MILITARY SPECIFICATION

TEST SET, INVERTER, CONVERTER CHASSIS ASSEMBLY: 11748234

This amendment forms a part of Military Specification MIL-T-48599 (MU) dated 11 April 1977, and is approved for use by the U.S. Army Armament Research and Development Command, and is available for use by all Departments and Agencies of the Department of Defense.

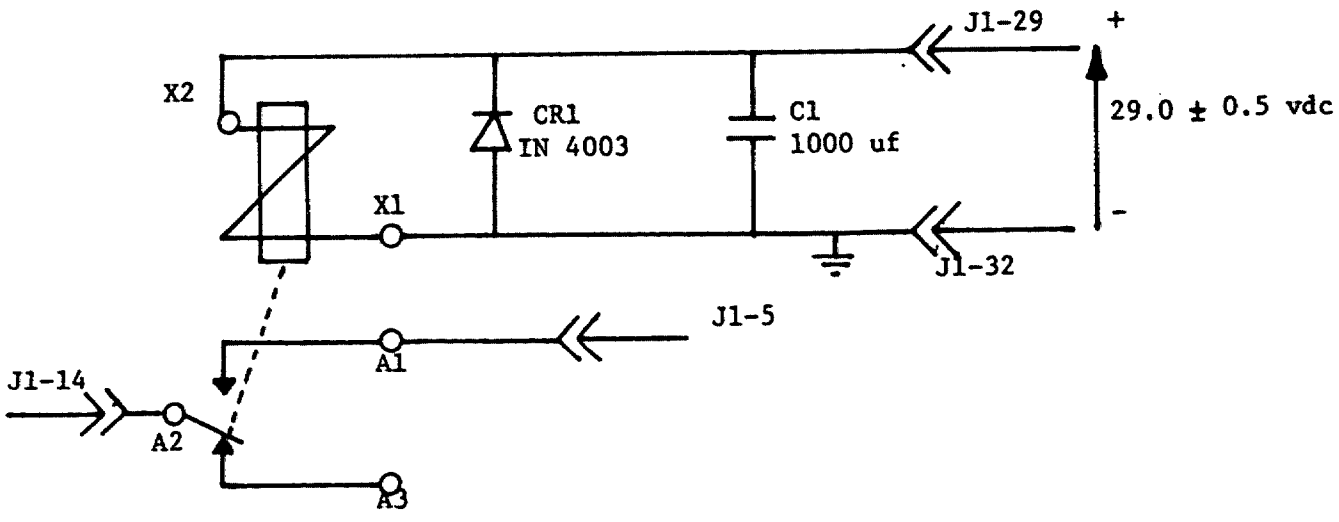
Figure 1, Delete in its entirety and substitute new Figure 1.

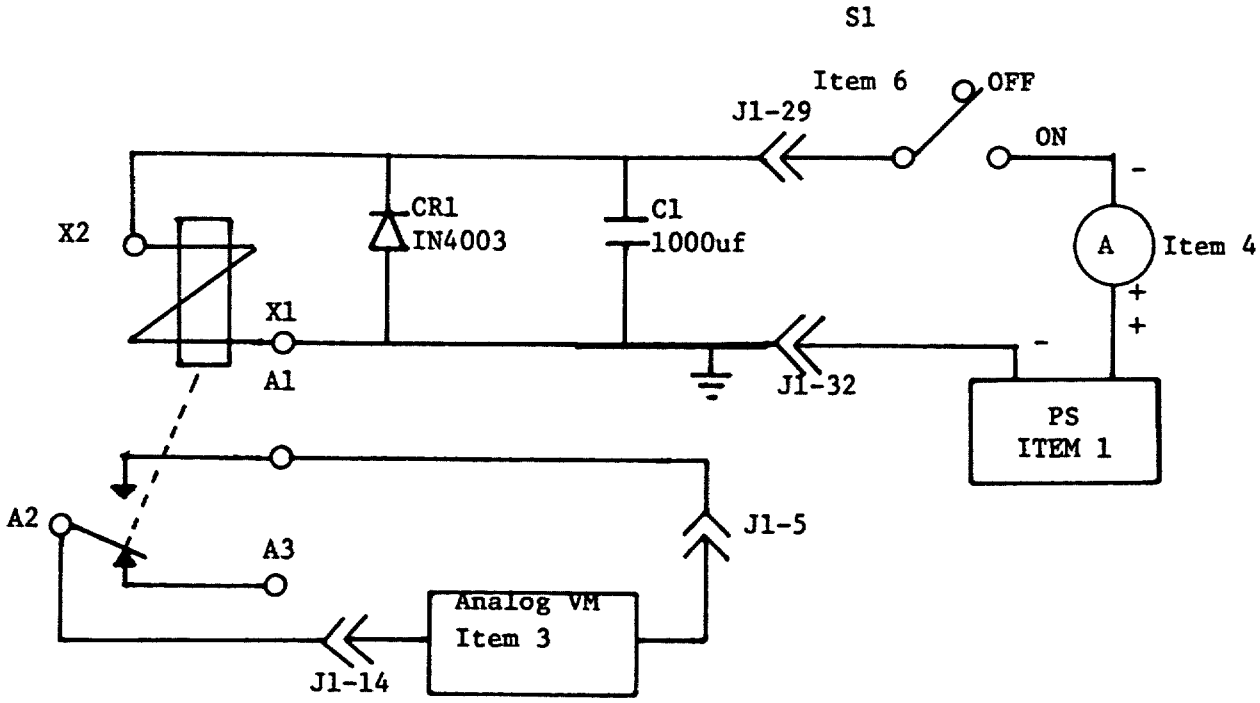
Figure 13, Delete in its entirety and substitute new Figure 13:
